MTW / HVO Lemington Underground Mine Water Storage Project HVO South

SUBMISSIONS REPORT

HUNTER VALLEY OPERATIONS

Figure 1: Plan of of Lemington Underground Mine and surface features in the vicinity.

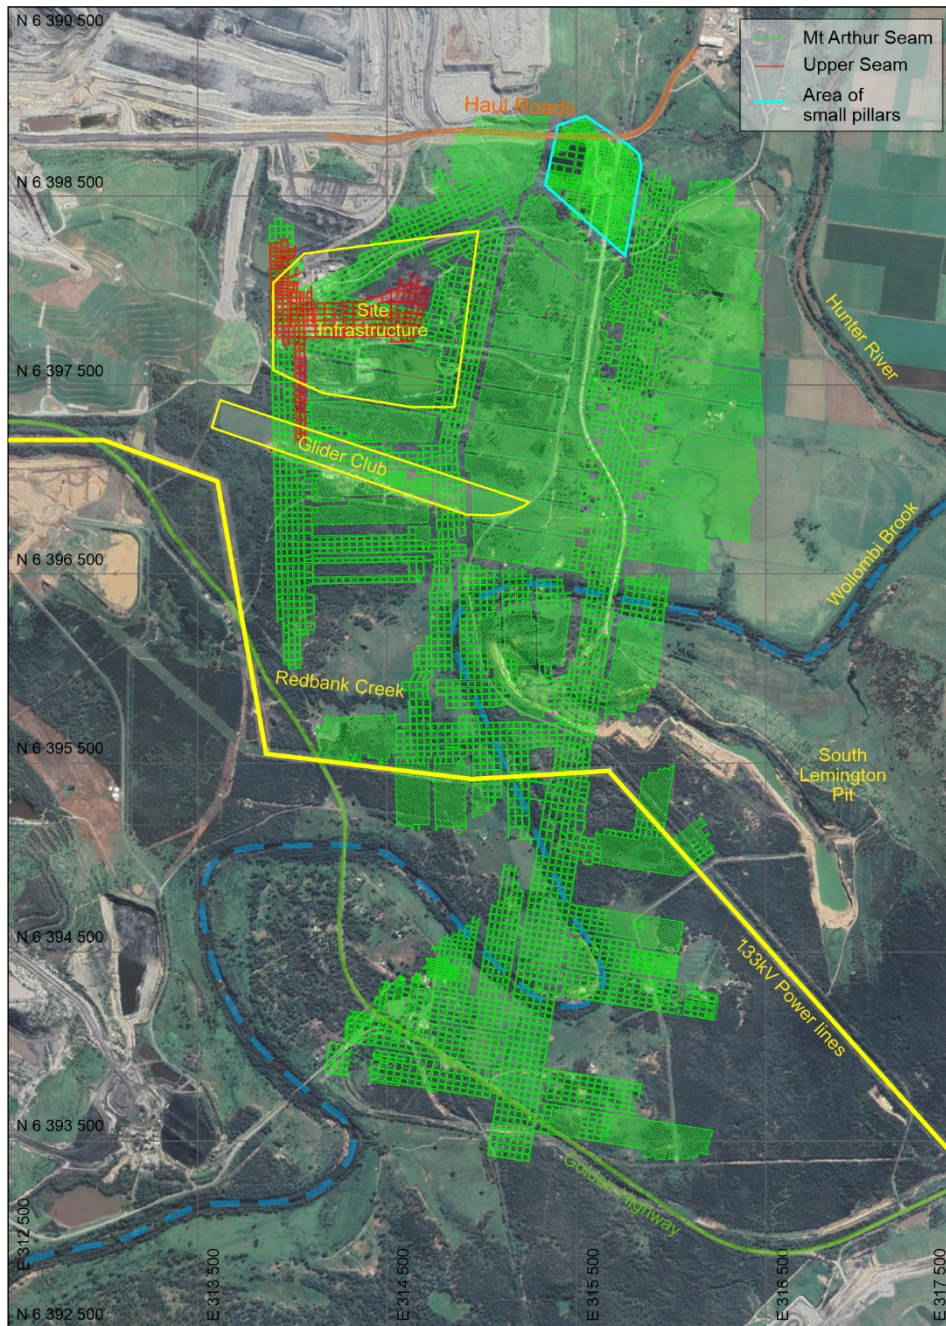
The BCD recommends that HV Operations Pty Ltd assess the subsidence risks associated with using the bord and pillar mining void to store water. The BCD states that *“The Lemington Underground Mine extends beneath the Hunter River, Redbank Creek and Wollombi Brook. Surface disturbance of the workings could impact these water courses, including changing the longitudinal stream profile gradient and streambed cracking.”* The BCD also notes that *“Surface disturbance from the subsidence of the old Lemington Underground Mine has the potential to expose the Hunter River, Redbank Creek and Wollombi Brook to an increased frequency of flooding or to flood risks that may not have existed previously.”*

An approximately 20ha area of small split and quartered pillars in the northern part of LUM, shown in Figure 1, is likely to be exposed to wetting and drying if the water level cycles in the underground mine cycles above about RL5m Australian Height Datum. The surface above this area, owned by HVO, would be vulnerable to sudden subsidence if pillar instability occurs. However, as this area is not close to the Hunter River, Wollombi Brook or Redbank Creek, there would be no potential for this subsidence to impact these watercourses.

Rib spalling in this area of small pillars is expected to become sufficient over time to reduce the nominal probability of failure to between 1 in 100 and 1 in 300. This probability of failure is not considered long-term stable and surface subsidence in this area could therefore be expected to develop at some stage. Pillar instability of any one of the numerous small pillars in this panel would be expected to lead to sudden subsidence of up to 1.5-2m across most of the panel. Two haul roads, various minor roads and road intersections, and a dam appear to be the main surface infrastructure currently located above this panel of small pillars. The land is owned by HVO.
